SECTION 00 91 13
ADDENDA

ADDENDUM:	<u>No. 2</u>
ADDENDUM DATE:	<u>August 26, 2024</u>
BID DATE:	<u>August 29, 2024</u>

This **ADDENDUM** is issued to institute the included changes and/or deletions to the Plans and Specifications for the **IFB# 026-45 HALL COUNTY-SPOUT SPRINGS WATER RECLAMATION FACILITY EXPANSION TO 1.6 MGD** project and hereby becomes a part of said Plans and Specifications.

PLANT DRAIN DEMOLITION PLAN AND PROFILE

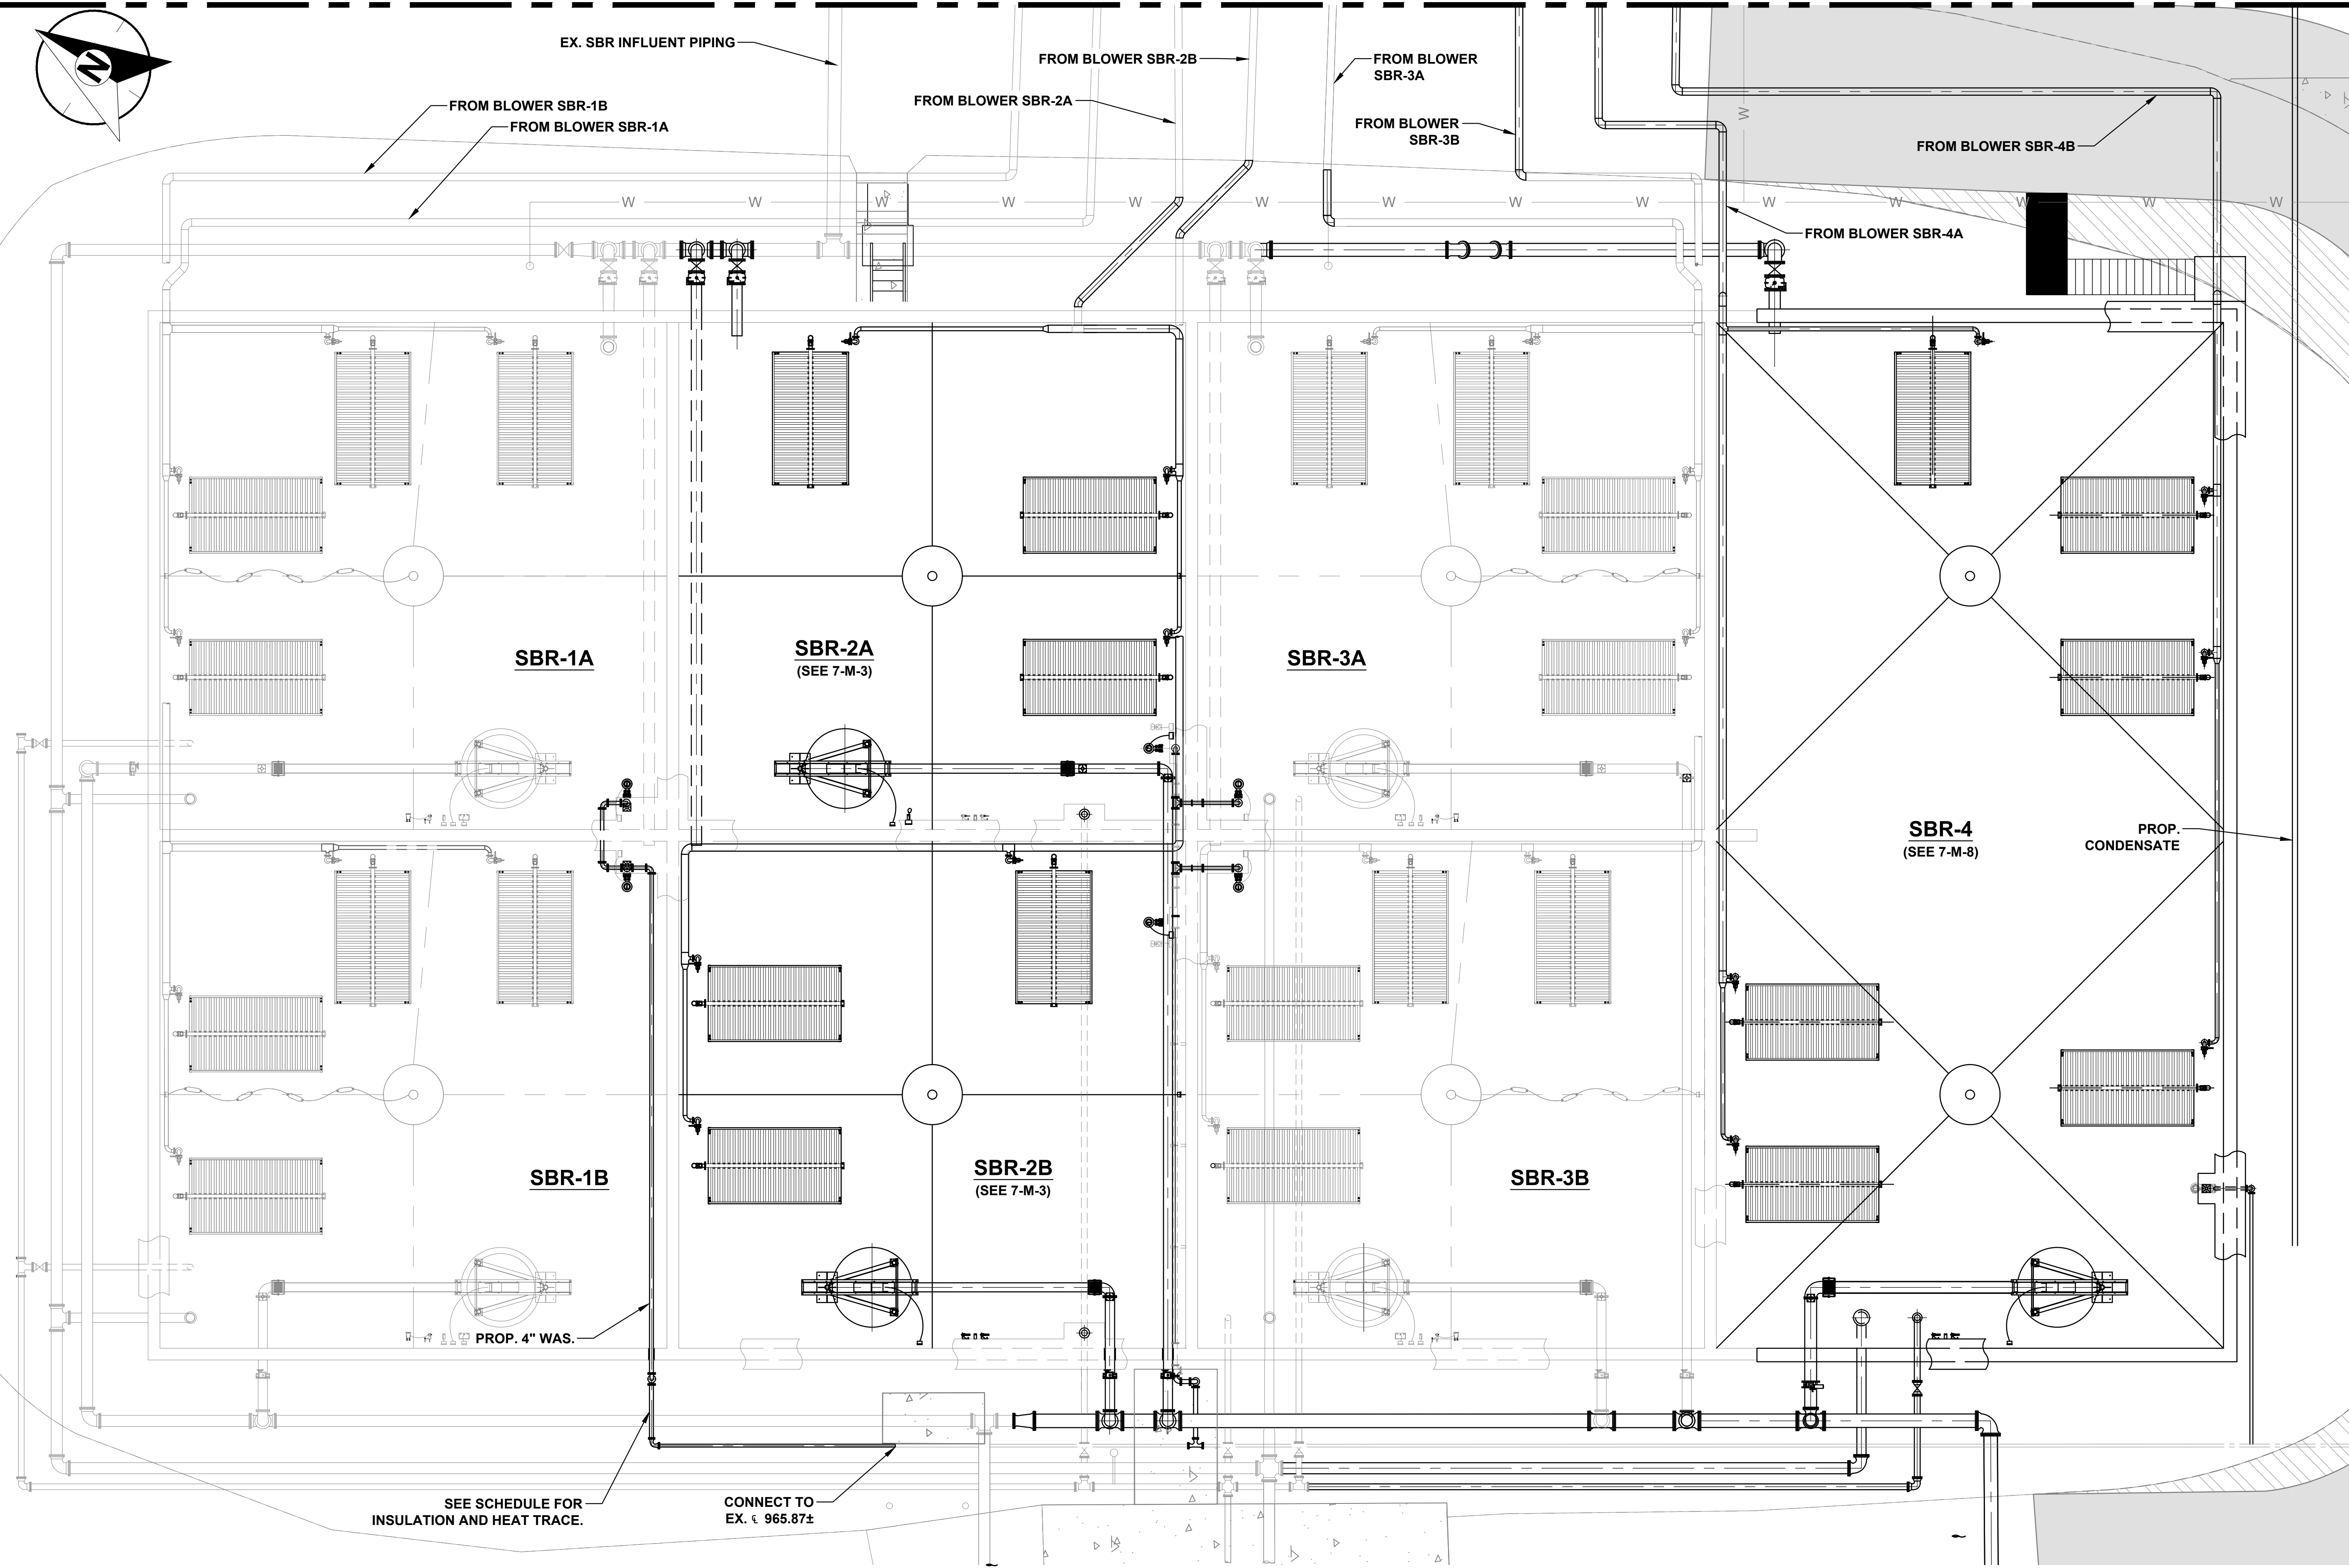
25. Drawing 3-C-5, shows an existing 8” Drainpipe West of MH 14A (see bottom right of drawing), but there are no drawings showing what happens to the existing 8” drain pipe? Does it get removed or plugged after MH14A (to East?), was there a MH there before? Please clarify scope.

Refer to the attached Drawing 3-C-6G for information.

7-M-2
OF
212

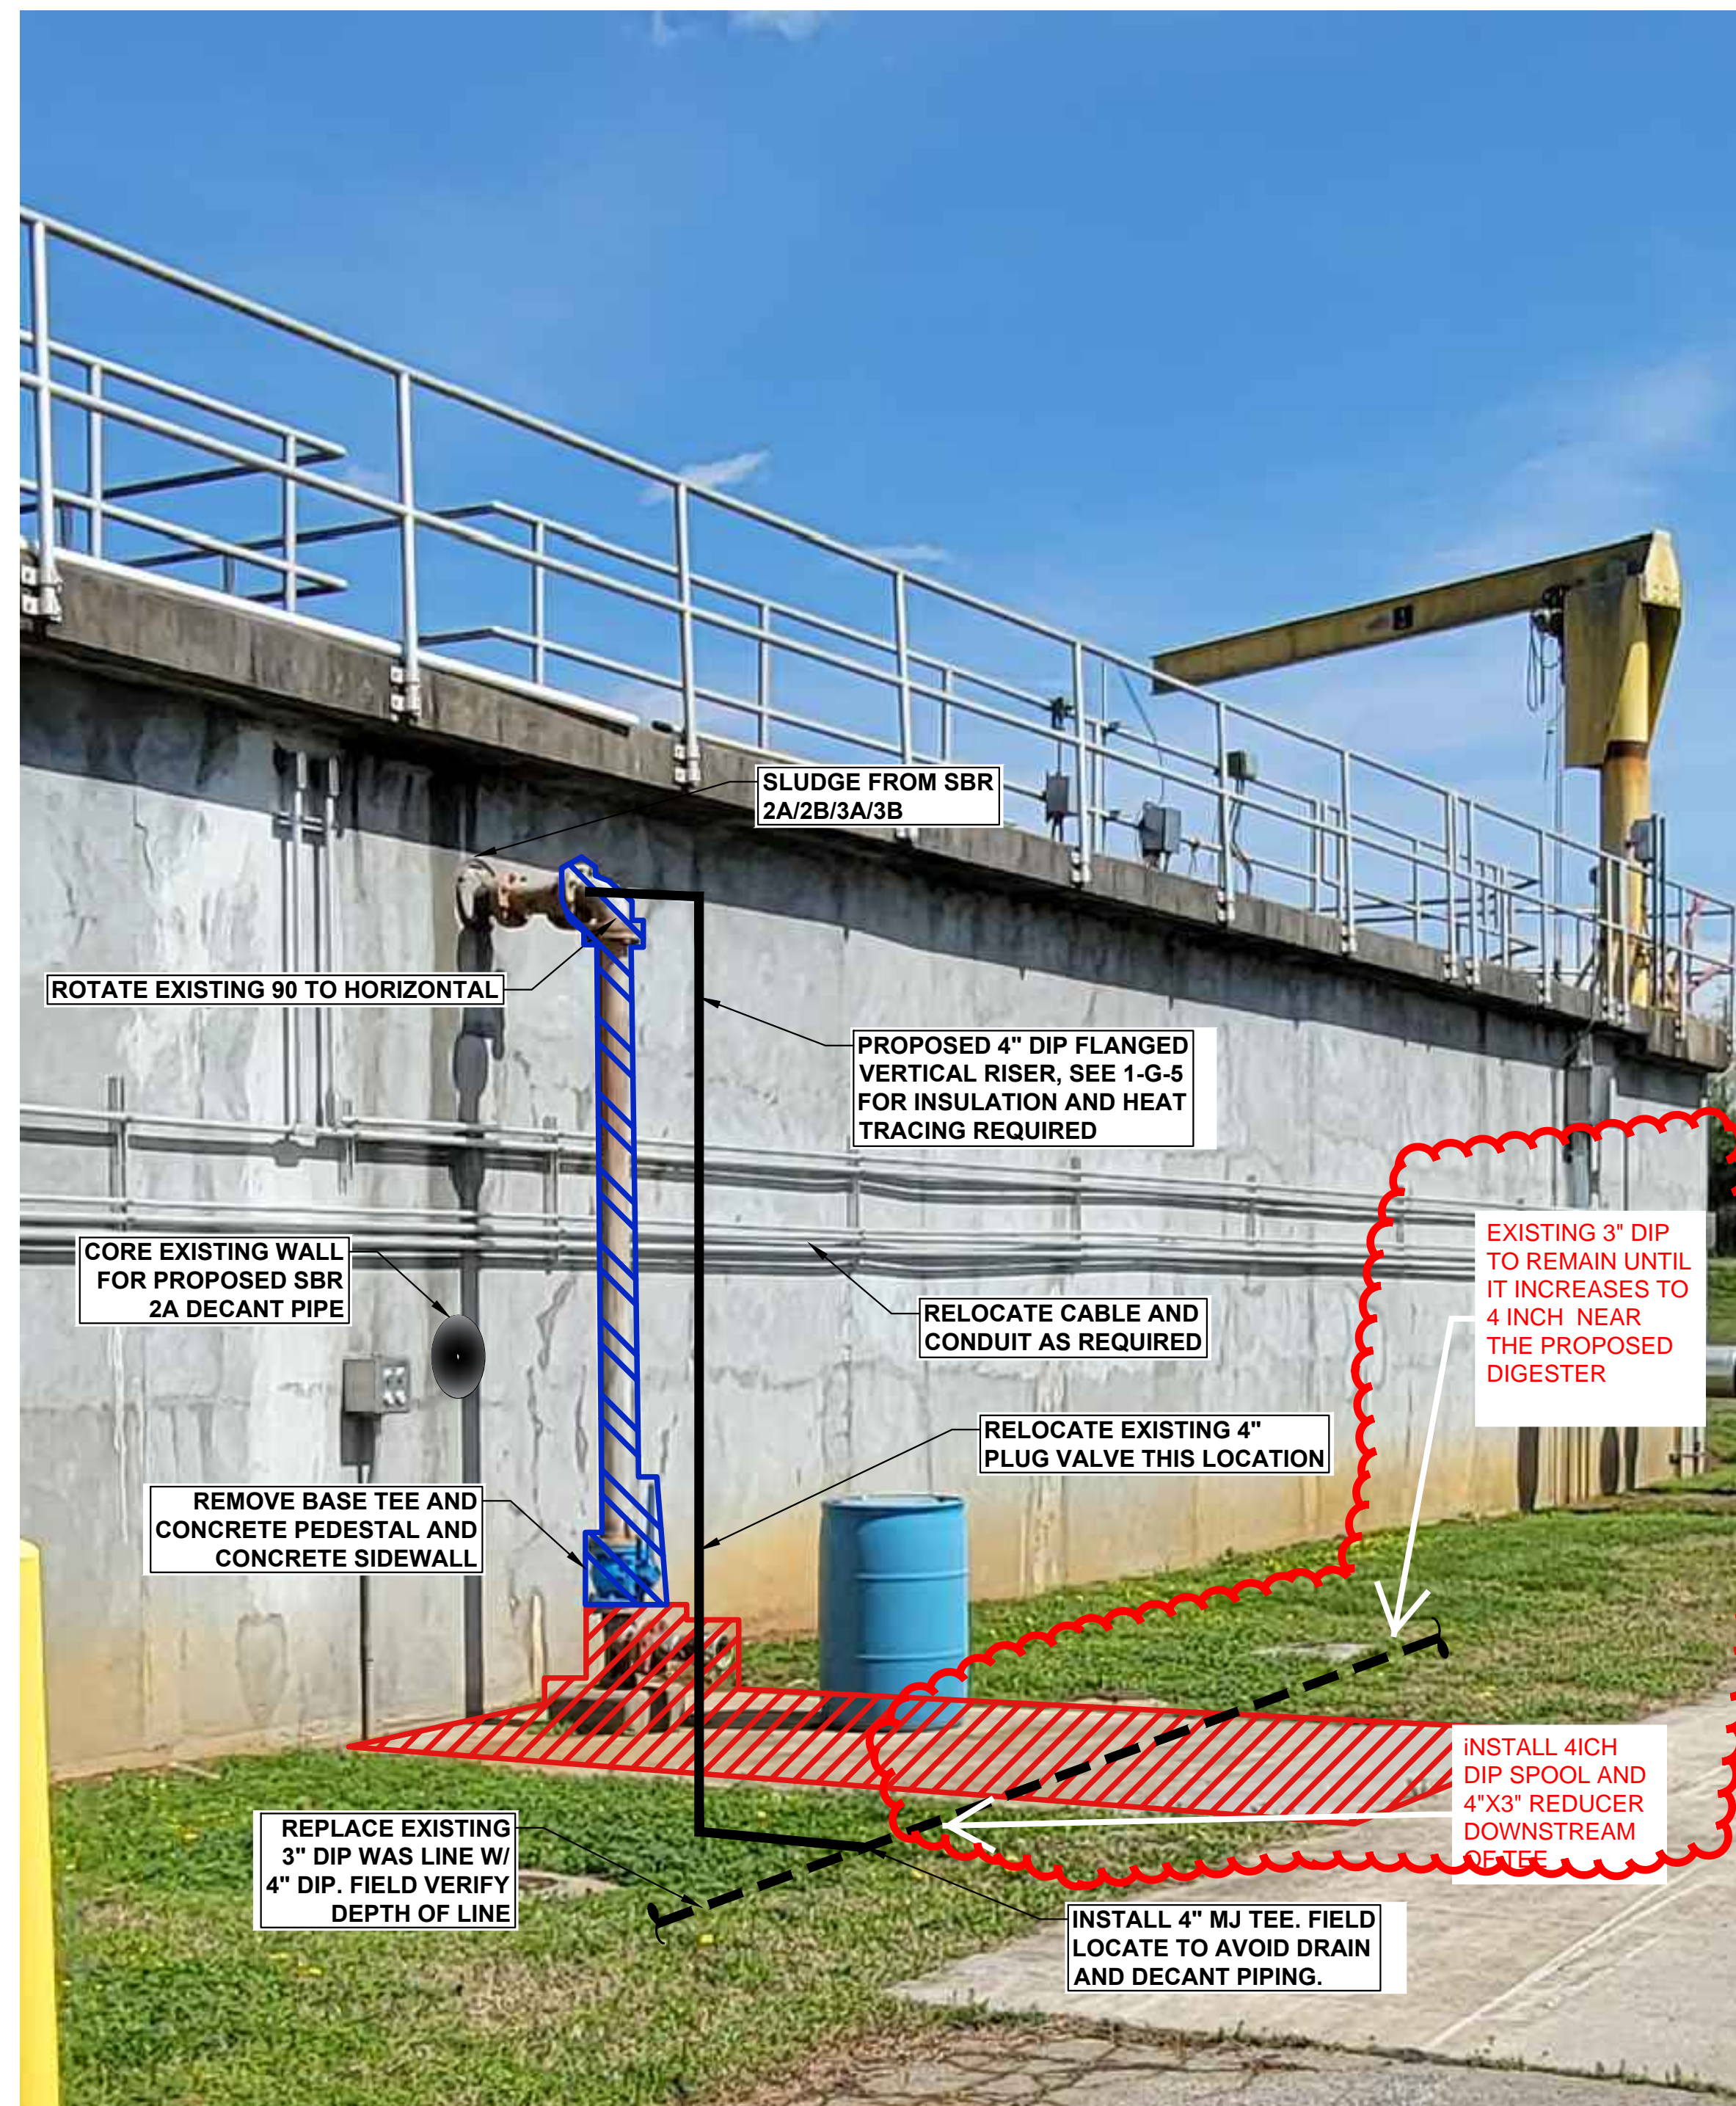
14. Drawing 7-M-2 between the Existing Blowers and SBR-2A & 3A there are approximately three sections of bold air piping with a callout "MODIFIED AIR PIPING", but there are not any existing drawings showing how the existing piping is configured. Please provide existing drawings to determine the modification scope.

15. Drawing 7-M-2 calls out “AIR PIPING SHOWN FOR REFERENCE ONLY BY OTHERS” and points to the pipe penetration at SBR-2A. Please clarify and confirm the Air Piping is existing from outside of the tank wall to the inside. It also appears the modified air piping to SBR-2A is drawn as flat, but in the photo on the same drawing shows the air piping going through the wall above ground. If modified air piping needs to change elevation please provide revised drawings.

71. Please correct the listed scale on plan sheets 7-M-1 & 7-M-2.

The air piping exists outside the basin wall. The outside SBR riser and pipe penetration through the wall are to be reused. The piping inside the SBR will be provided by Aqua Aerobics for installation by the Contractor. Refer to Drawing 7-M-3 and Note 1 on 7-M-4.

The scale on sheet 7-M-1 and 7-M-2 has been corrected. See reissued sheets.

WAS PIPING MODIFICATIONS AT SBR-2A & SBR-2B

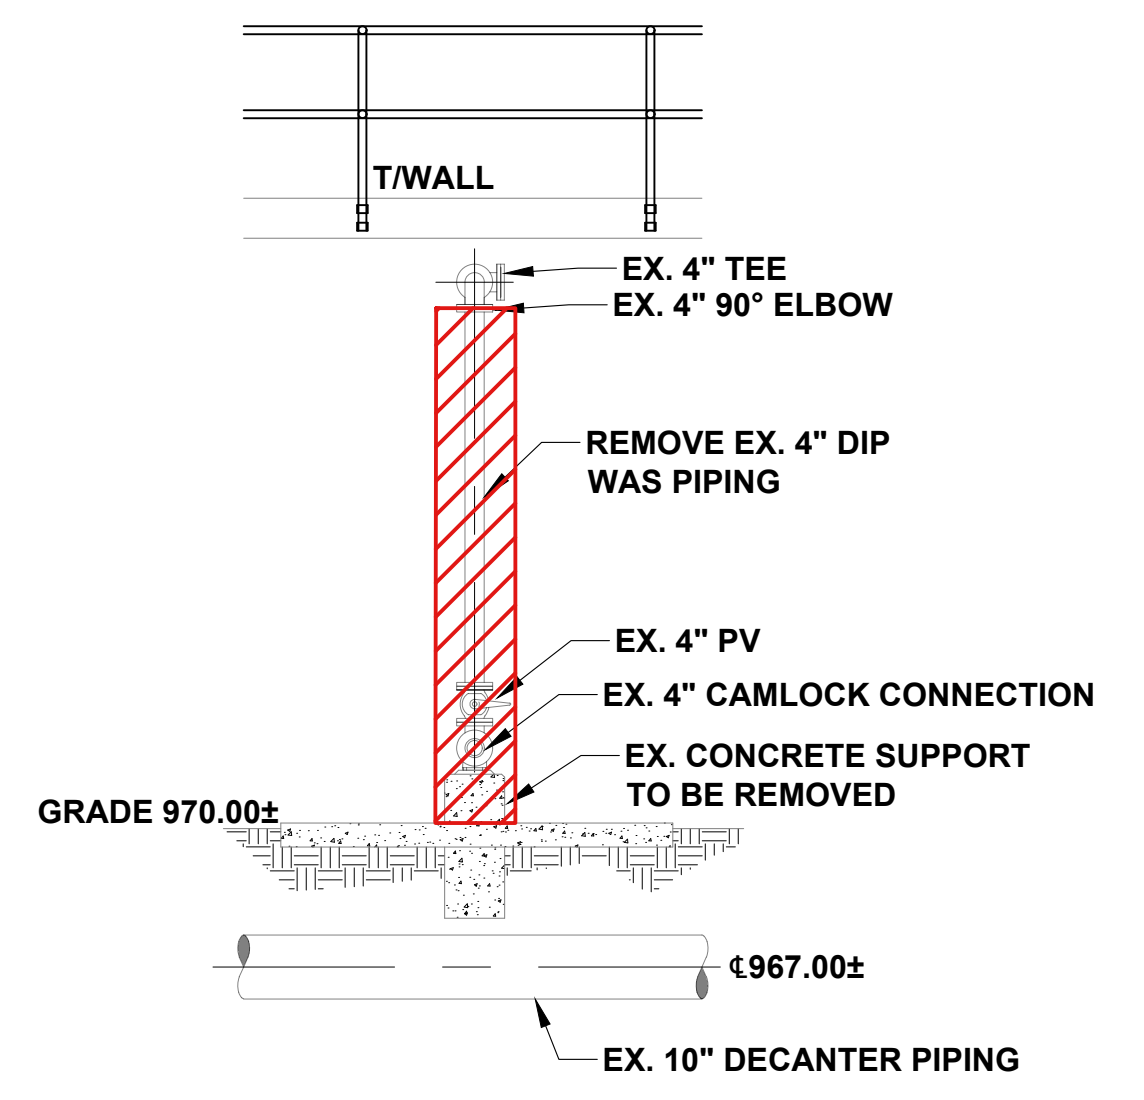
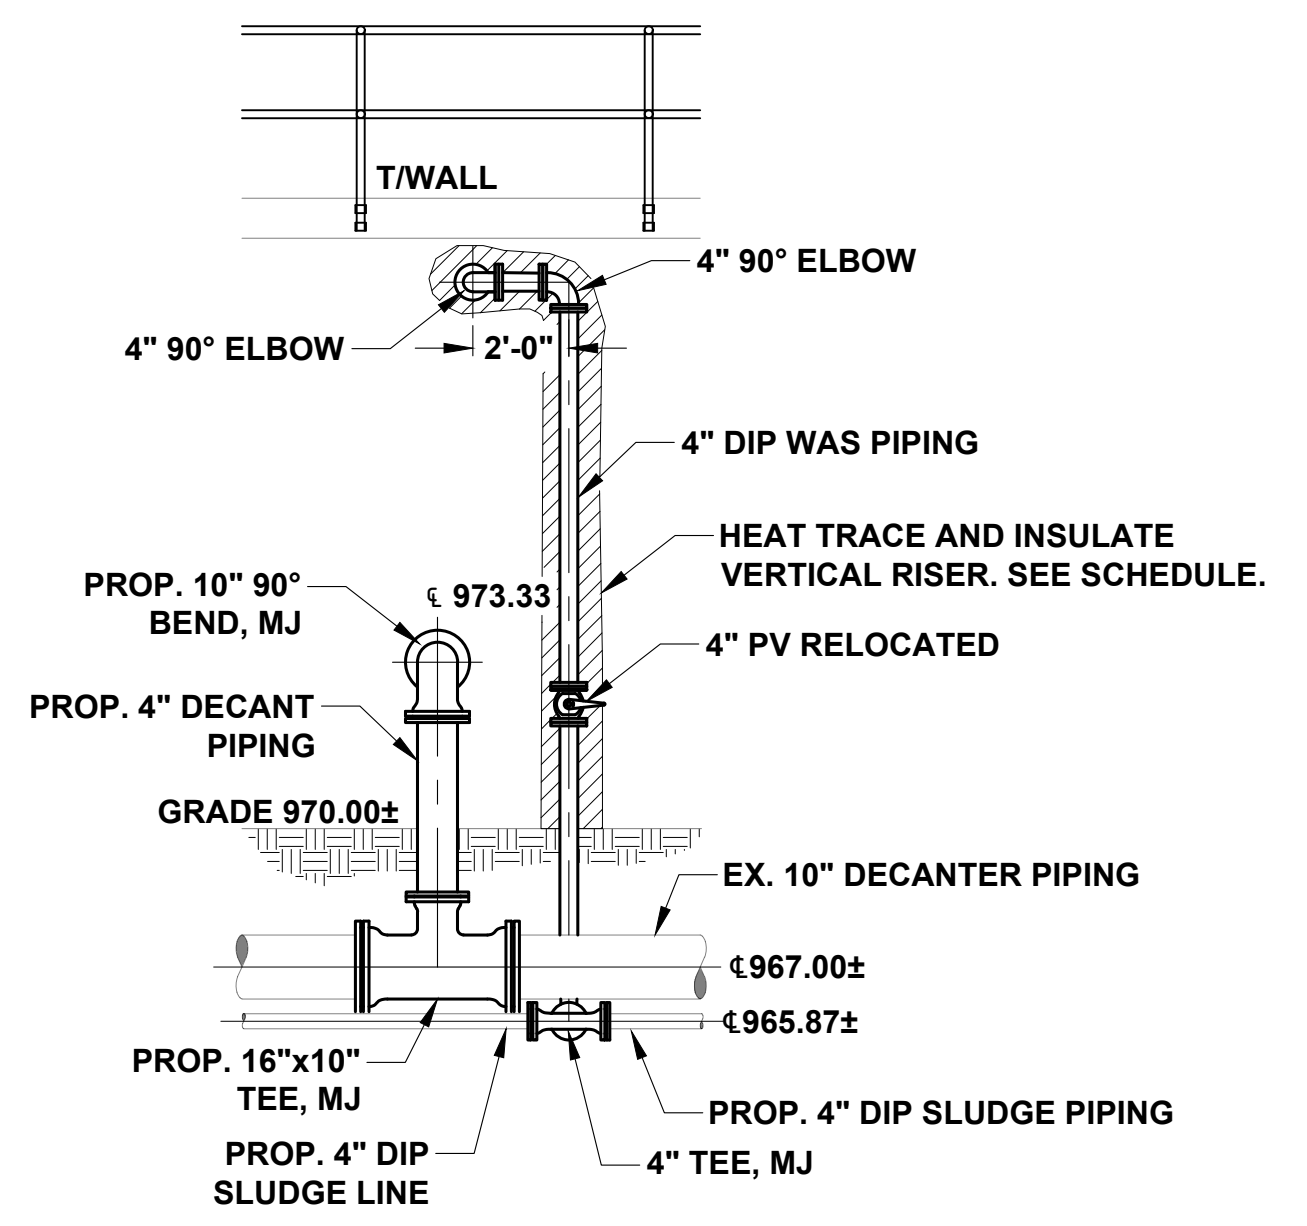
40. Drawing 7-M-4, Detail 4 calls out “REPLACE EXISTING 3” DIP WAS LINE W/ 4” DIP.” However, Drawing 3-C-5 does not show replacing the 3” WAS line with 4”. Please clarify which drawing is correct, and if 7-M-4 provide limit.

Refer to Drawing 7-M-4 attached for clarification.
